NCPC File Nos. MP165 and 6383

GEORGETOWN WATERFRONT PARK

REVISED DESIGN CONCEPT

Submission by the National Park Service

MODEL PHOTO OF WATER FEATURE AND PLAN DETAIL

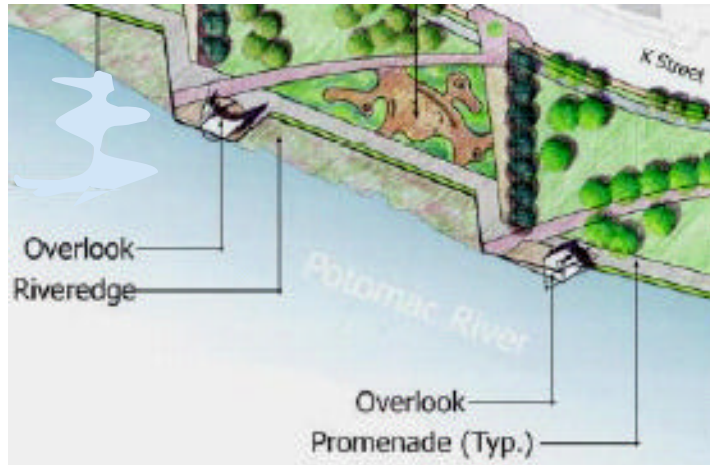
The central interactive water area at the terminus to Wisconsin Avenue is appropriately programmed as a park element. Its abrupt edge, however, at the feature's junction with the

stepped bulkhead is visually disruptive and incongruous with the treatment of other park elements, which appear to move and transition into their adjacent areas much more successfully and seamlessly. Perhaps the element requires only refinement of its southern and eastern edges to allow some form of overlap or horizontal extension both out over the bulkhead and east over the steps. Such an approach would allow the development of a recess to obscure any necessary service or mechanical access entries to the lower areas of the interactive water area. Another approach would be to physically separate the two elements with some form of transitional area between the two. Whatever the method, the objective sought is essentially a better transition between the water feature and the open descending steps.

- Better integration of the central water feature area with the steeped shoreline terminal focal point at the base of Wisconsin Avenue.
- Increased height of the vertical elements of the overlooks (and possible increased horizontal projection of the overlook deck) at their locations at the shoreline.
- Introduction of a floating boat-docking pier for temporary docking at the concrete stepped shoreline.

OVERLOOK PLAN DETAIL AND PHOTO OF MODEL OF TYPICAL OVERLOOK

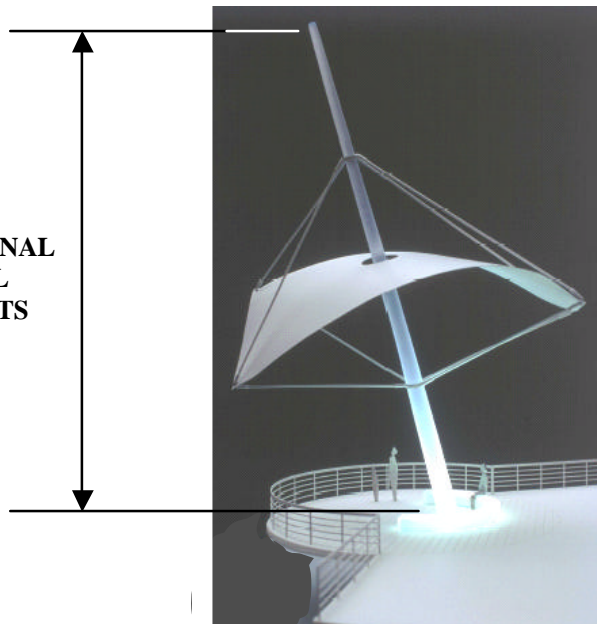
The issue of the overlooks is one of only fine-tuning, as staff is very pleased with the successful placement and basic appearance of the overlook design. The overlook locations adjacent to the public promenade offer park users panoramas of the river and an opportunity to approach and extend out over the river. Their character evokes a maritime theme and each is centered around a tall, color-tinted, translucent “mast” which is internally illuminated at night. The base of each overlook provides seating, a wood-planked floor, railing, and all sheltered by a translucent shade element supported from the mast. In total composition the overlook design is very engaging. Staff believes, however, the scale of the vertical mast is somewhat short and maybe lost to the

background of the park and surrounding Georgetown area as the waterfront, in the future, is further developed. Staff believes an increase in height is appropriate for the mast elements.

**REQUEST ADDITIONAL
HEIGHT TO ALL
OVERLOOK MASTS**

PLAN DETAIL OF STEPPED BULKHEAD AREA WITH PHOTO OF MODEL HIGHLIGHTING POTENTIAL DOCKING AREA

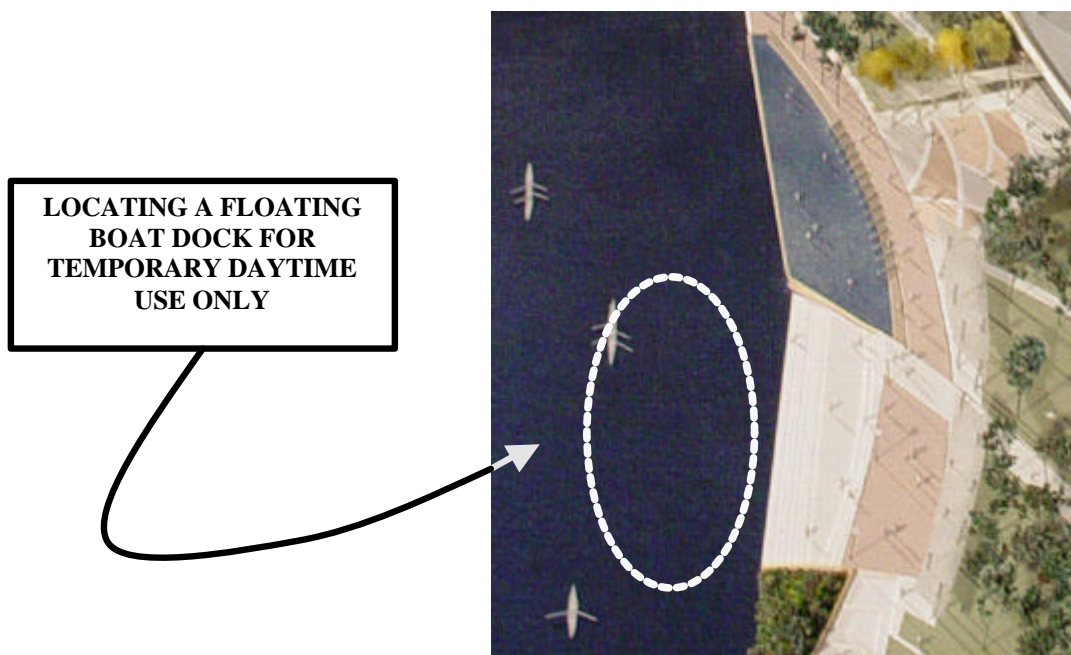
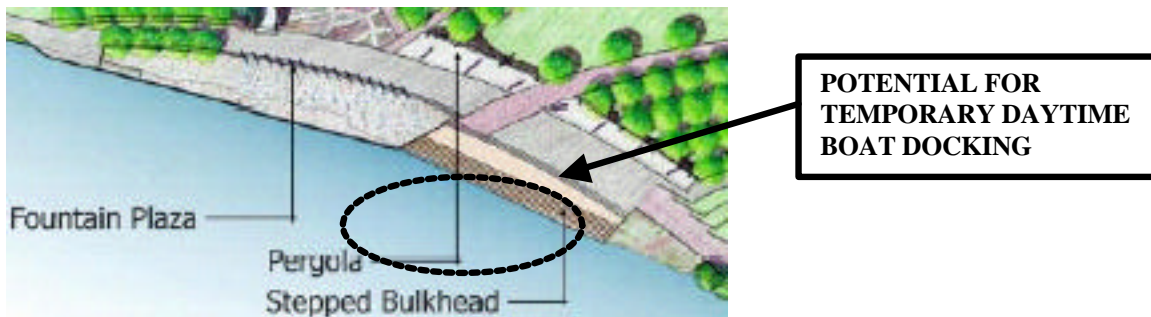
Finally, staff recognizes the careful consideration achieved by the design team and NPS in the development of the stepped bulkhead concept and the issues of public interaction at the rivers edge. However, staff believes the unique opportunity to be at the water's edge includes the

adjacent proximity of many of the elements and activities that occur at or on the water, including boating and the attraction and interest boats generate from all ages of people. To provide the chance to move down to the water, but not to have boats of all types near-by to view and approach, leaves something missing from the waterside experience. Consequently, staff concludes it is appropriate to consider a limited-scale floating boat dock (for boat mooring only) at the stepped area that could be closed “after park hours”. The staff appreciates the logistic requirements such an activity evokes but careful design and planning can achieve this use in a public park setting, as is demonstrated by many lakeside and riverside parks found in metropolitan areas such as Pittsburgh, Saint Louis, Buffalo, and Alexandria, VA. Should there be obvious need to implement guidance to control powered craft, versus the need for non-motorized boat activity during certain periods of the year, the staff finds it appropriate that NPS would work with stakeholders to determine what types of control might be feasible.
